<b>Subject:</b> RATTLE NOISE FROM HEADER PANEL OF CONVERTIBLE TOP	<b>Bulletin No:</b> 09-045/15
	<b>Last Issued:</b> 12/04/2015

2016 MX-5 vehicles with VINs lower than JM1ND\*\*\*\*\*107384 (produced before October 26, 2015)

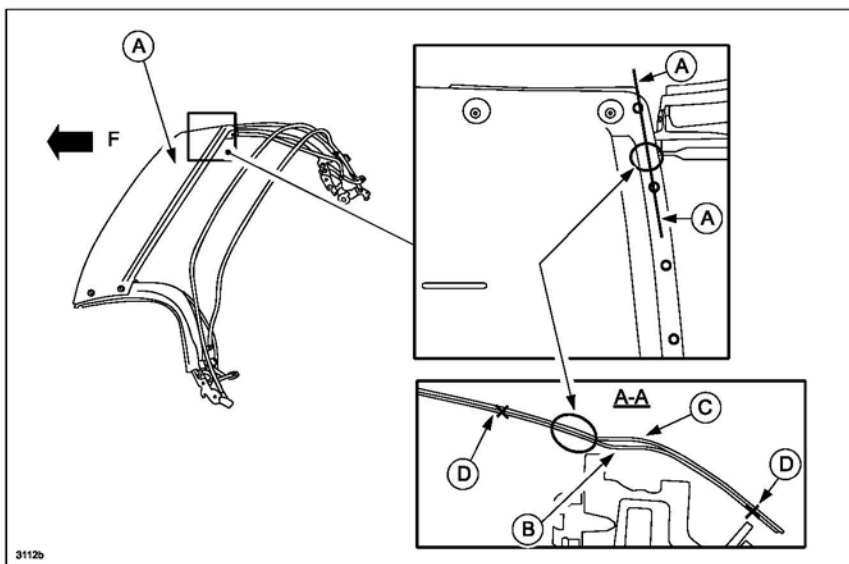
Some vehicles may exhibit a rattle noise (A) from the header panel (B) of the convertible top when driving on a rough road.

The header panel (A) is formed by two aluminum panels, inner (B) and outer (C). When receiving an input force by driving on a rough road, the two panels at the problem area, where spot welds are located (D), may warp and change relative position causing the rattling noise. (F=Front)

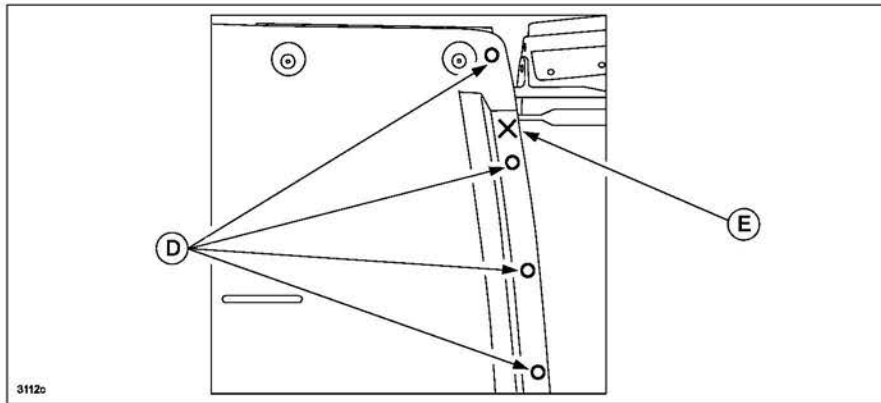
To correct the problem, a spot weld (E) has been added to the problem area, where the original spot welds are located (D), to increase the rigidity and prevent the warping.

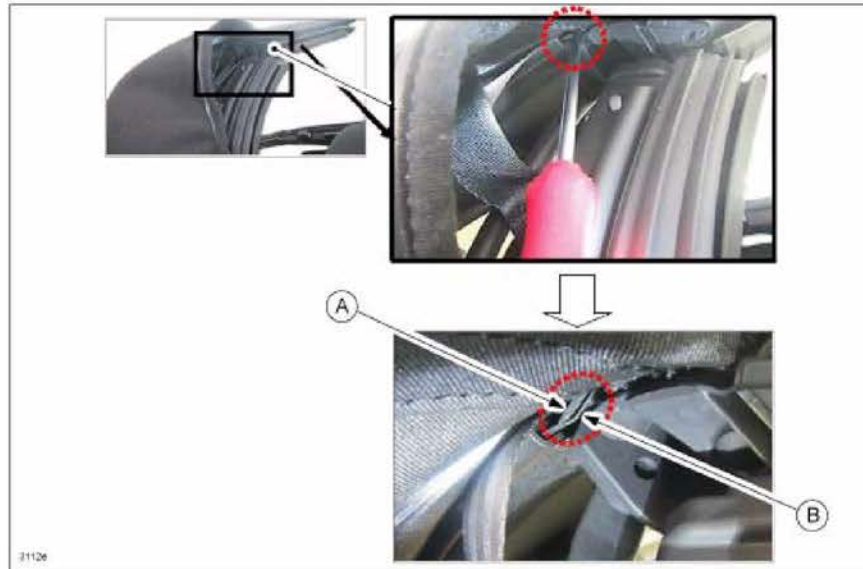
1. Verify customer concern.
2. Enlarge the gap between the inner and outer panel of the header panel at the problem area (both driver and passenger sides) using the following procedure.
  - a. Open the convertible top to a position where the area to work (A) is the most accessible as shown.

- b. Using a flat-blade screwdriver with protection tape on the tip, enlarge the gap between the outer (A) and inner (B) aluminum panel of the header panel about 1-2mm at the problem area.
